CONSIDERATION OF AND/OR ANY APPROPRIATE ACTION ON PANORAMA STREET PRELIMINARY PLAT, SITUATED IN THE PHILLIP ANDERSON SURVEY, ABSTRACT NO. 10 CITY OF PARKER, COLLIN COUNTY, TEXAS. [MACHADO]

Re: Panorama Street
 Preliminary Plat and Engineering Plan Review

As you requested, we have reviewed the Preliminary Plat & Engineering Plans for the Panorama Street Addition prepared by LJA Engineering, Inc. These documents include a new street and is therefore considered a major subdivision under section 155.025 of subdivision ordinance.

PRELIMINARY
DATE: JUN 2023
DESIGN: MARTINEZ
DRAWN: MARTINEZ
SCALE: 1" = 40'
HORZ: N/A
VERT: N/A
SHEET
30
OF 35 SHEETS

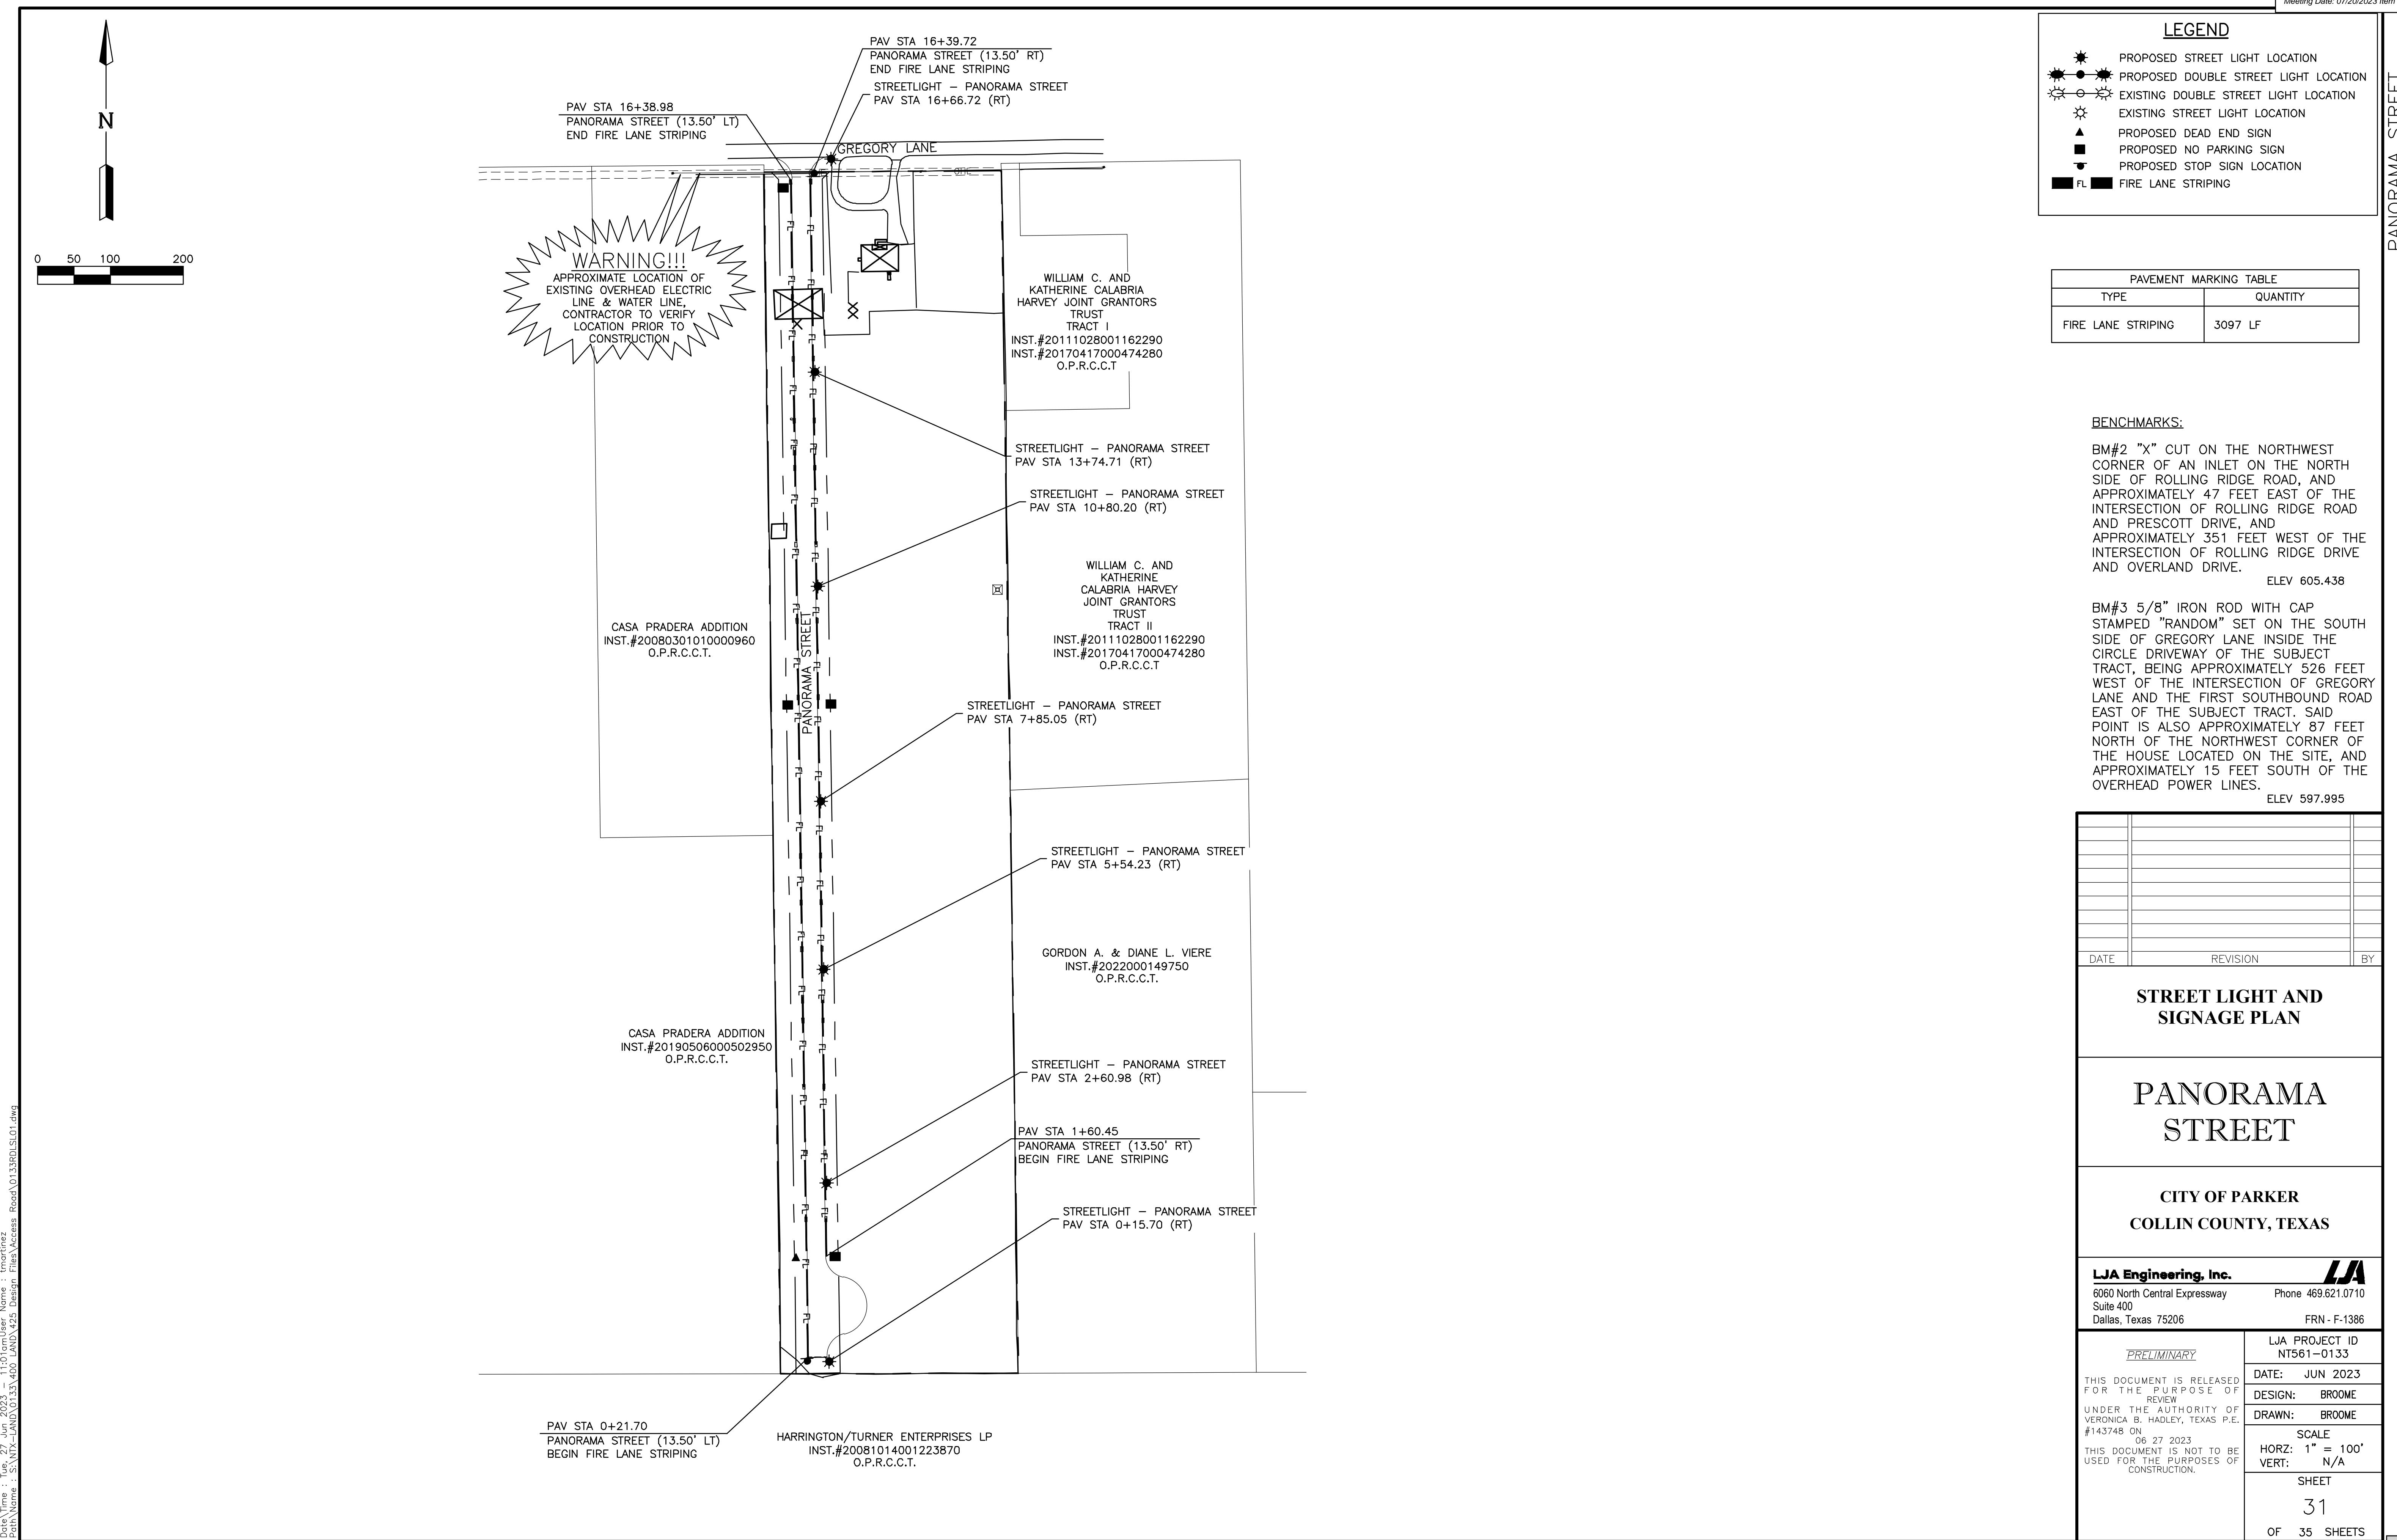
72. Sheet 29 Provide the depth of the rock rip rap and the geotextile fabric foundation.
73. Sheet 30 Utilize radius pipe and eliminate pipe bends in the storm sewer pipe.

74. Sheet 30 Provide the depth of the rock rip rap and the geotextile fabric as foundation.

75. Explain how overflow functions. How can it be lower than the 100-year water surface you are detaining?
76. Sheet 30 Show the freeboard in the in the elevation sections of the pond.

77. Sheet 30 Show and dimension the keyway associated with the berm being constructed.
78. Sheet 30 Provide the outlet structure for the South Pond. Vee Notch or Stepped Weir must be designed for the 1, 25, 50 and 100-year storm.

79. Sheet 30 Outlet pipe from the pond must be normal to the receiving channel.
80. Sheet 31 Remove fire lane markings as this is a city street.
81. Sheet 31 Provide Dead End street sign at Gregory Lane, having at end of the street is too late to advise the public.

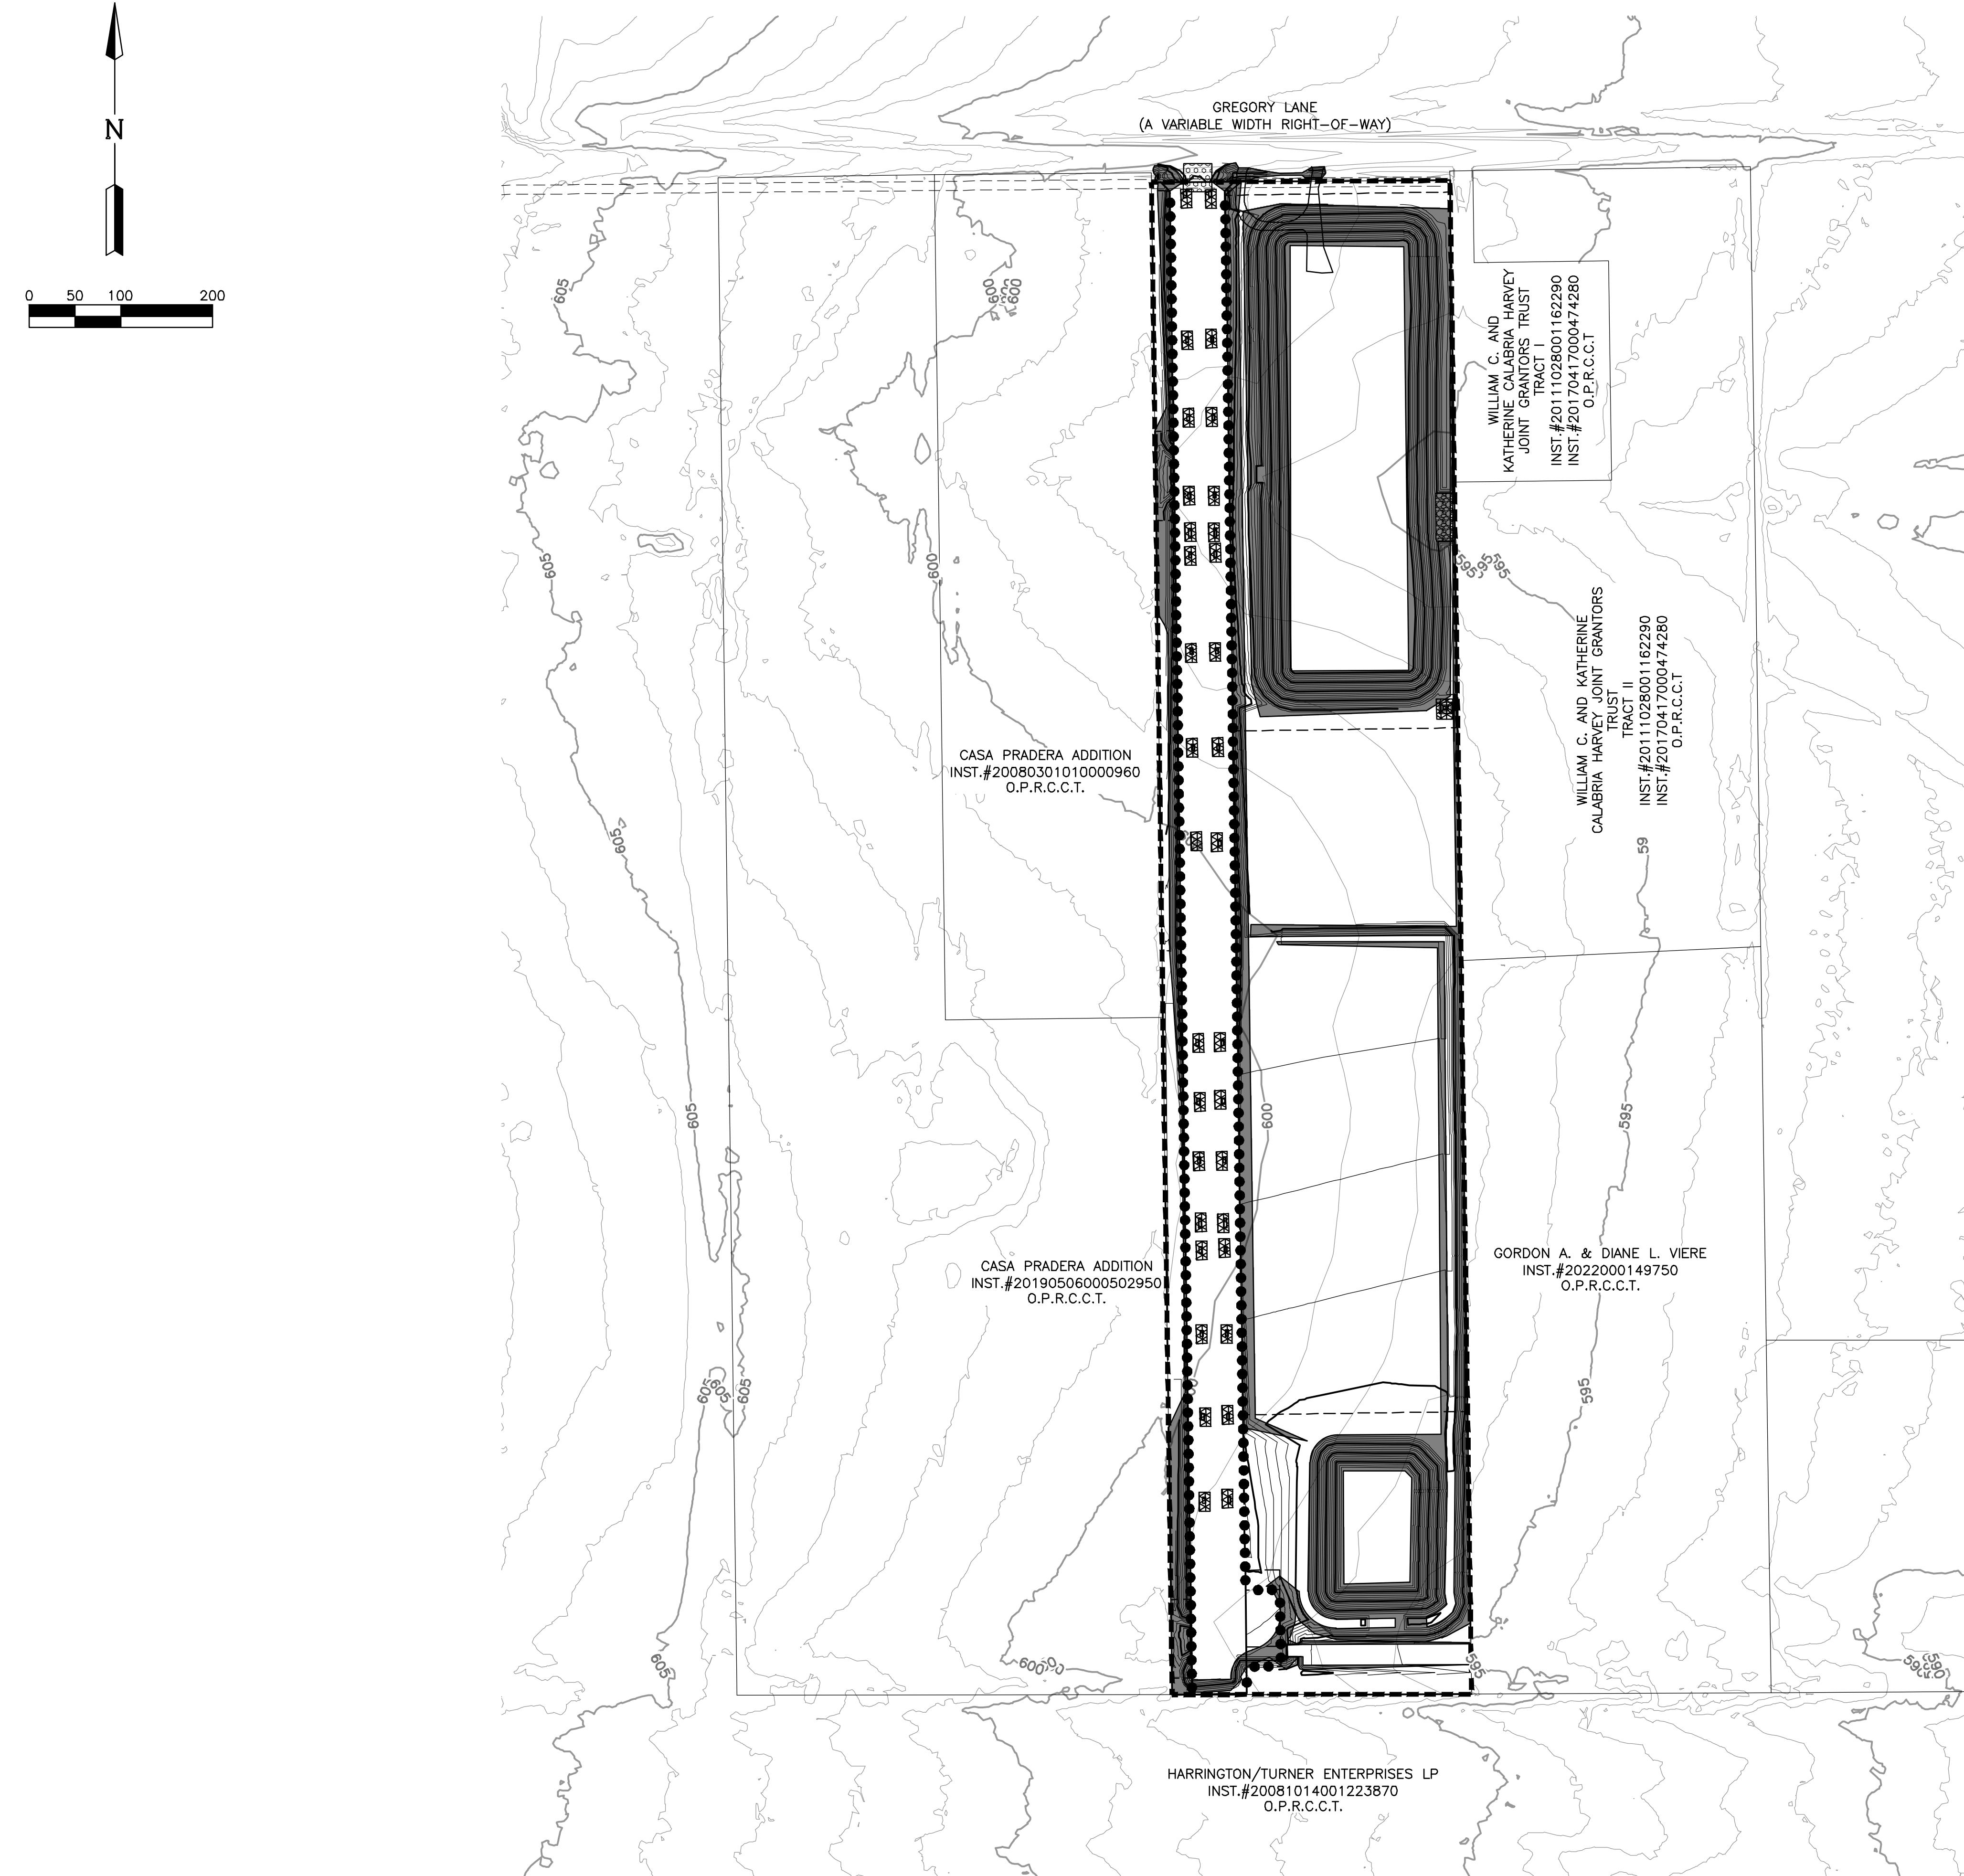
85. Sheet 32 Provide in notes method to establish vegetation as set forth in subdivision comments. Provide notes on how to place curlex. Contractors without instructions continue to fail at this task.

86. Sheet 32 Provide note on what contractor is to do if they encounter rock in the excavation and how to undercut, import topsoil, compact and establish vegetation. Consider pinned solid sod on slopes.
